Engineering Memo		Document #: BLTN-032
		Revision: B
Created By: Jim Brock		
Release Date: Jan 11, 2018		
Reporting Upset OD on 6.625" IEU Drill Pipe/Slip-Proof™

Purpose

This bulletin is to document the changes in Grant Prideco’s method for dimensioning the finished upset OD/Slip-Proof™ tube OD on 6 5/8” IEU pipe. Grant Prideco adopted a new standard for upset OD/Slip-Proof™ tube OD dimensioning in the 4th quarter of 2014 with the installation of the Titan welder and the design of single piece Slip-Proof™ sections.

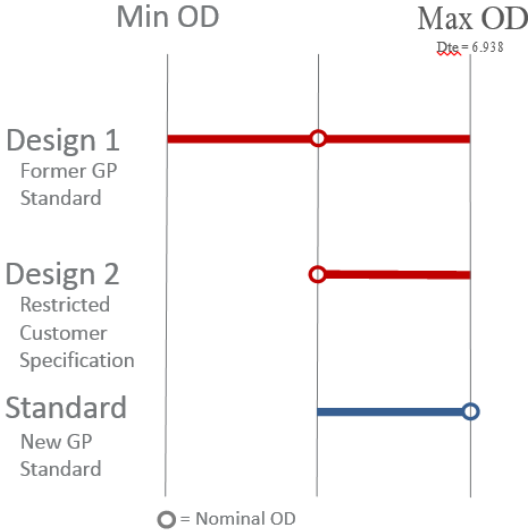
Design 1: The former GP standard had a nominal dimension of 6.906” with a plus/minus (+/-) tolerance. Maximum OD is 6.938”.

Design 2: GP also had a special requirement design for WSI that had a nominal dimension of 6.906” with a tolerance of +0.032. That was driven by maximizing the weld strength for assets such as 6 5/8” 0.938” UD-165 Slip-Proof™ landing string. Maximum OD is 6.938”.

Design 3: The latest GP standard has a nominal dimension of 6.938” with a minus (-) only tolerance. Maximum OD is 6.938”.

Going forward Grant Prideco will utilize Design 3 for all 6 5/8" OD IEU Slip-Proof™ . Design 3 increases the minimum weld OD which increases minimum weld area/strength and maintains API D_{TE} as the maximum OD. The change to Design 3 provides Grant Prideco consistency for manufacturing across all sizes of Slip-Proof™ products.

Functionally, there is no difference in Designs 1, 2 and 3. All three designs are interchangeable. As shown in the figure above, the range of Design 3 is within the range of the two previous designs. The maximum 6.938" OD is consistent and within the API 5DP D_{TE} requirement. Slips, elevators, and other pipe handling equipment are not affected.

This bulletin provides notice to WSI customers that 6-5/8" Slip-Proof product will be inspected and qualified based on 6.906" nominal OD.

- 6.906" for the upset and Slip-Proof™ tube nominal OD
- 1.703" for the nominal Slip-Proof™ wall thickness

The FASTR Performance Sheets will be revised to reflect the max D_{TE} as 6.938" and the Slip-Proof™ OD will remain the nominal dimension of 6.906" with a wall thickness 1.703". All reference and accessory designation will remain 6.906". Performance properties and inspection criteria will be determined based on the above nominal dimensions. This will allow consistent inspection criteria for mixed assets in inventory.
